Recall Campaign

June 2019
FL761A-C
NHTSA #18V-157 (School Buses)
#18V-158 (Non-School Buses)
Transport Canada #18-119 (School Buses)
#18-120 (Non-School Buses)

REVISED NOTICE

Subject: TBB Minotour Wheelchair Lift Interlock

Figure 2: Current Harness Installation

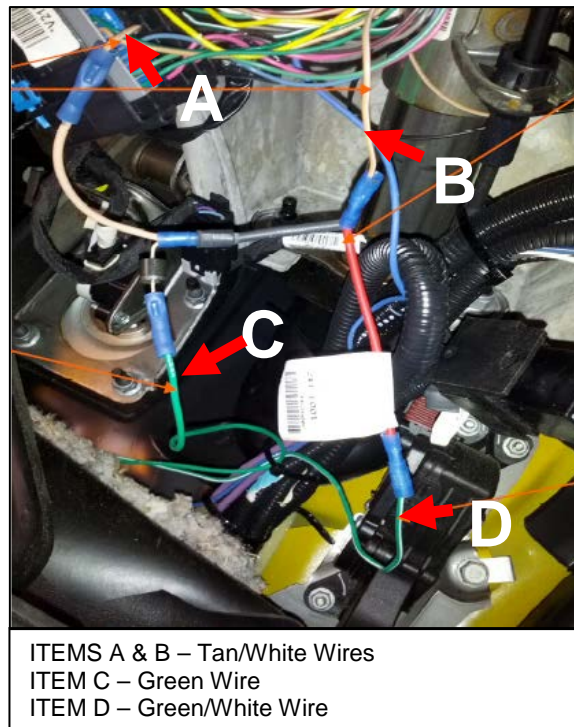
3. Cut the two brown wires between the connectors shown in **Figure 2 Items A and B** as close to the butt splice as possible (to allow connection to the new harness).

4. Install new harness TBB 175974 as shown in **Figures 2 and 3**.
 - 4.1 Connect the new harness to Positions A and B, where the brown wires were cut.
 - 4.2 Connect the existing green wire to Position C on the new harness.
 - 4.3 Connect the existing green/white wire to Position D on the new harness.

Figure 5: Connections at Relay

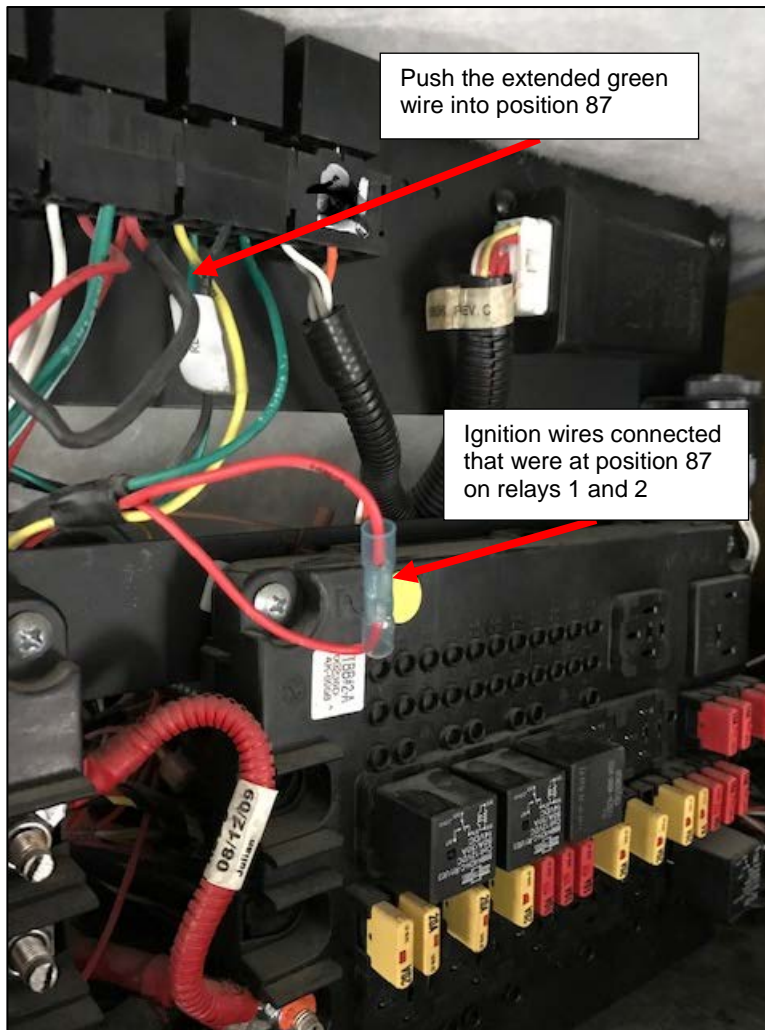
3. On relay 1 on the lift harness (on the metal mounting plate of the PC board), remove the ignition wire from position 5, which is 87 on the relay. See **Figure 5** for position and conversion of the relay block.
4. Put a spade terminal on the green wire that was added and plug it into position 5.

Figure 6: Schematic of Harness and Relays

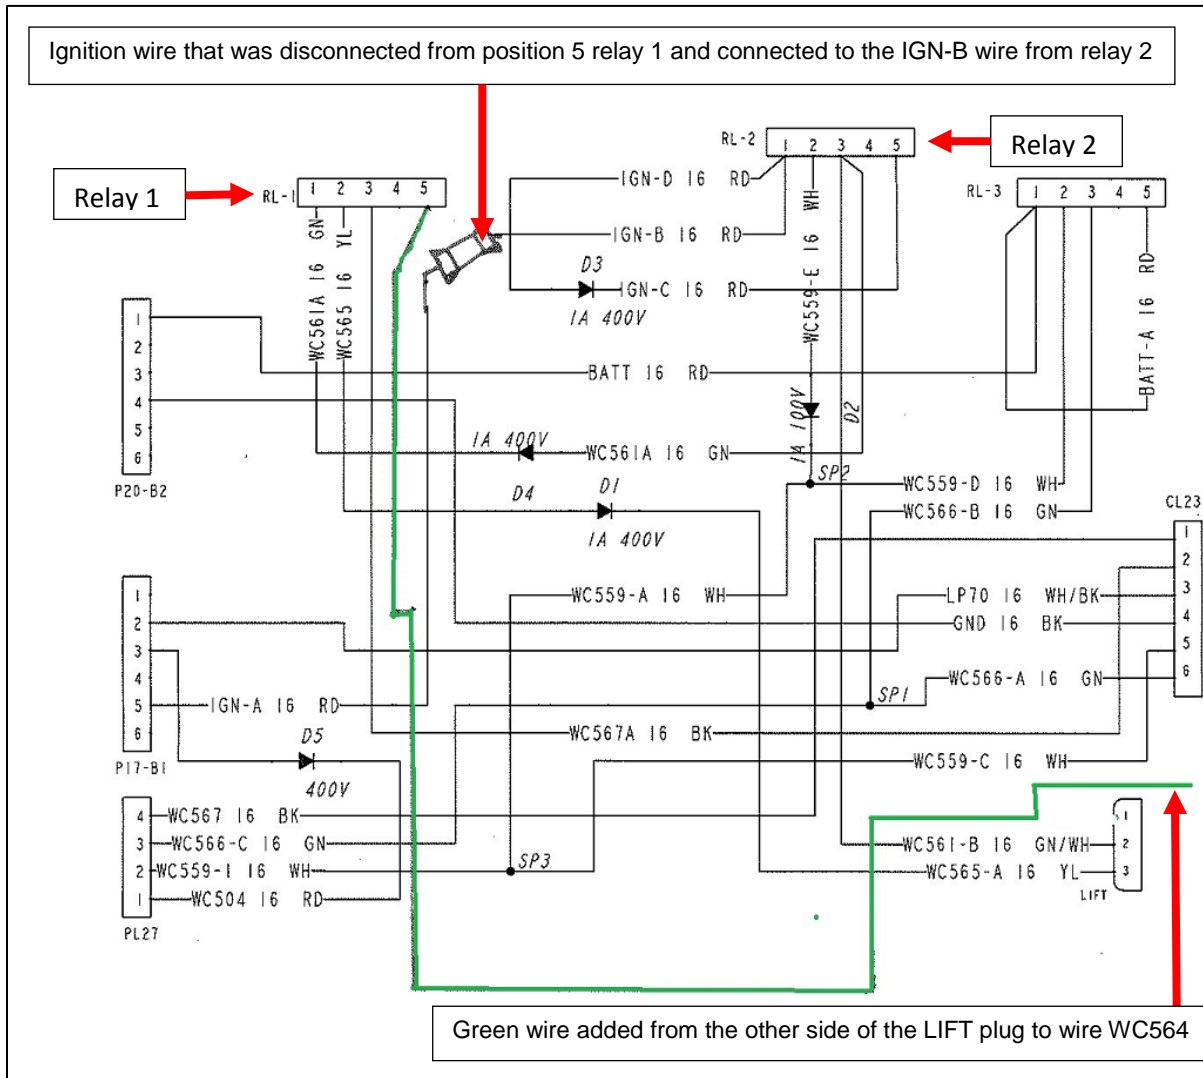
5. Connect the ignition wire that was in position 5 to the wire that was also in the same position 5 on the relay with a butt connector. See **Figure 6** and **Figure 7** for a schematics/diagrams showing the connections.

Figure 8: View of PC Boards

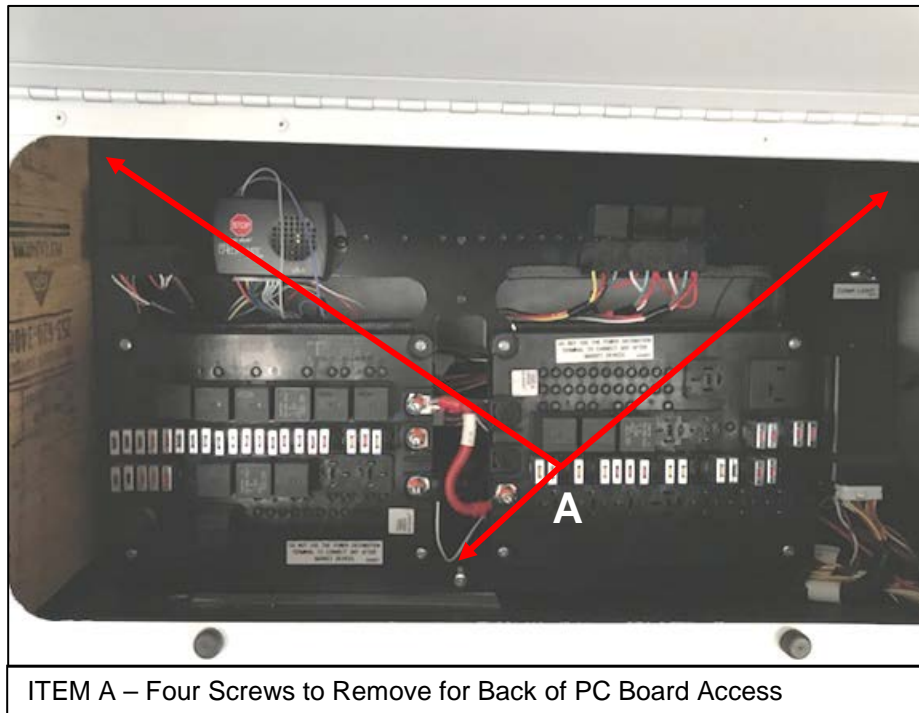
4. Open the PC circuit board cabinet (above the driver's seat) and prop the door open. See **Figure 8**.
5. Remove the three screws indicated in **Figure 8** and lay the PC board down.

Figure 11: Rear of PC Boards Showing Connections, Only

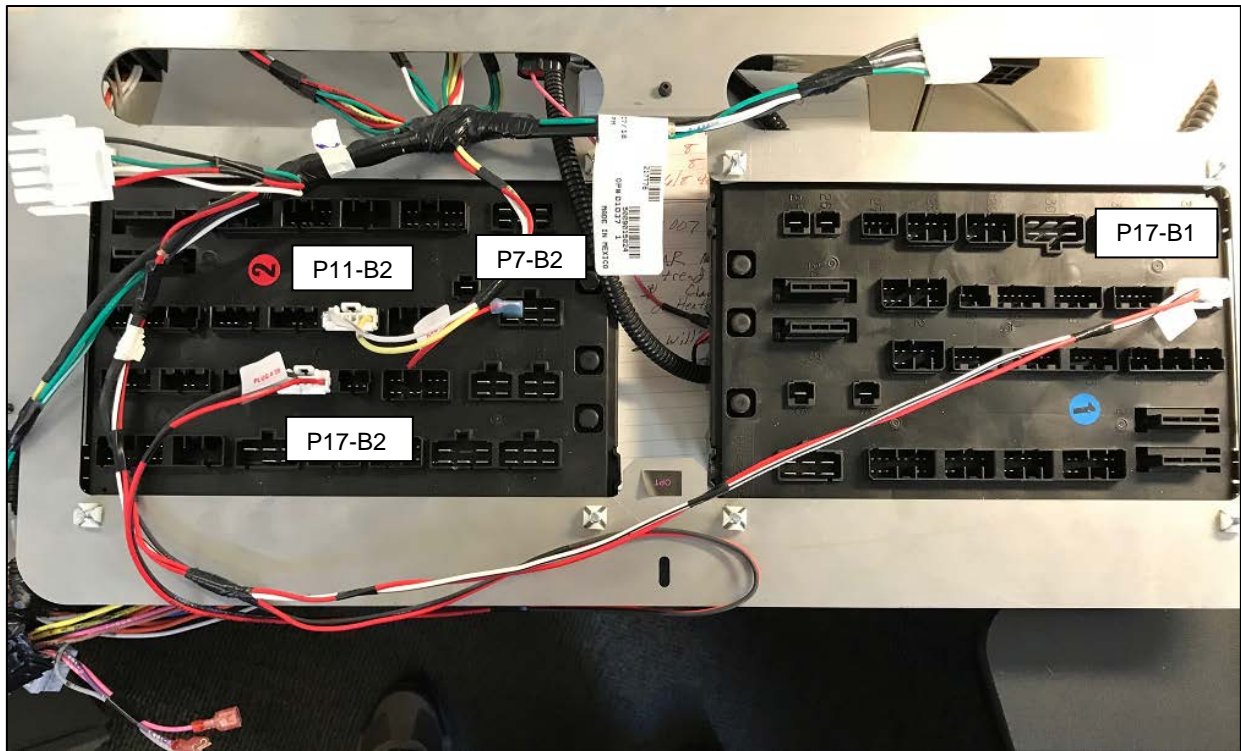
6. Remove the side cushion, retain it and screws. See **Figures 9 and 10**.
7. Remove the existing harness and install the new harness TBB 217778. The old and new harnesses have the same connection points on the back of the boards and connecting harnesses. **Figure 11** shows the locations on the back of the PC board. The remaining plugs on the harness will be connected to harnesses that are not plugged into the PC boards.

8. Remove each plug on existing harness TBB 150043 from the PC Boards one at a time and replace with the corresponding plug from the new harness TBB 217778. Once the PC board plugs are swapped, do the same with the remaining connections to harnesses as labeled.
